**Arthur River Deposit Hydrogeological
Review**

Beacon Hill Resources

MINEHOBAA00297AA_RE01

16 March 2010

Figure 1 Proposed site mining features and lease boundary (blue) (BHR PLC, 2009)

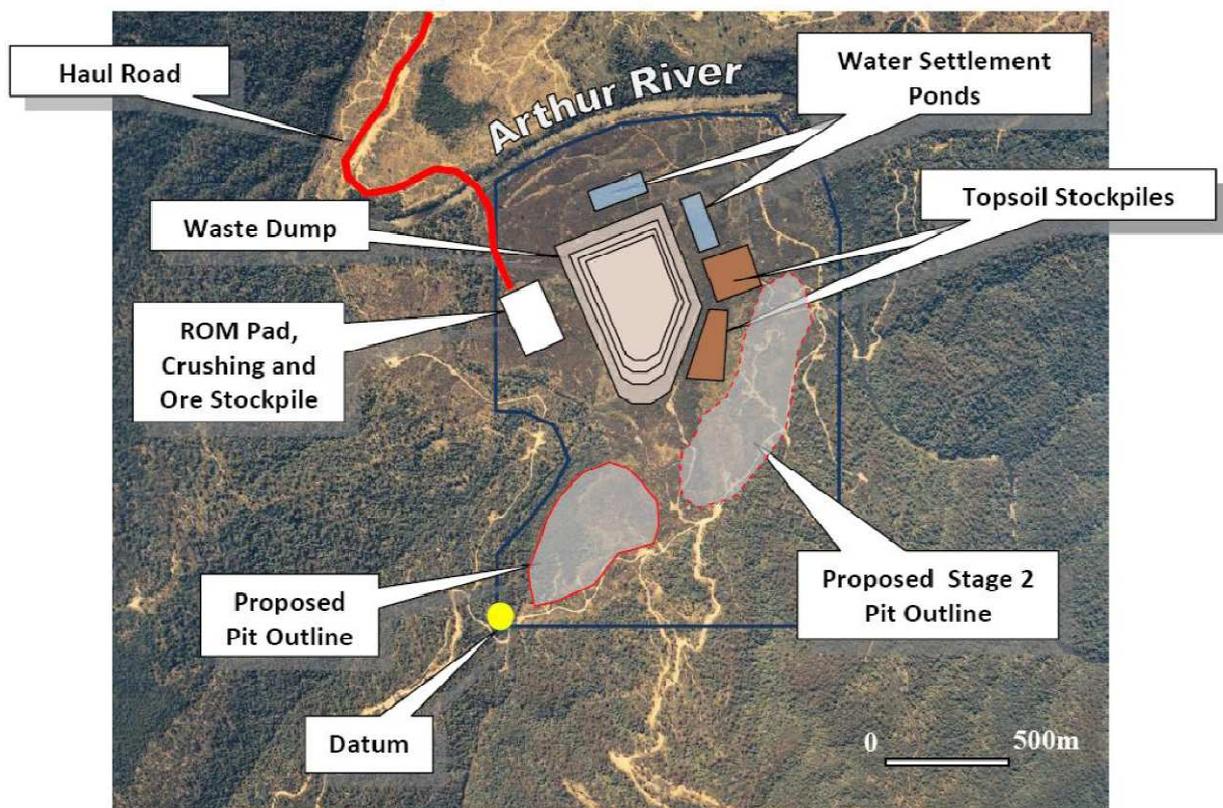
The likely contemporary water discharge property requirements for the mining operation need to be determined as part of the DPMP process and the site water management infrastructure designed accordingly. Both the proposed minesite layouts (Hatch, 1999 and BHR, 2009) allow only a minimal percentage of the available area for the storage (and treatment) of water relative to the available area available and that assigned for mine waste material (Figure 1).
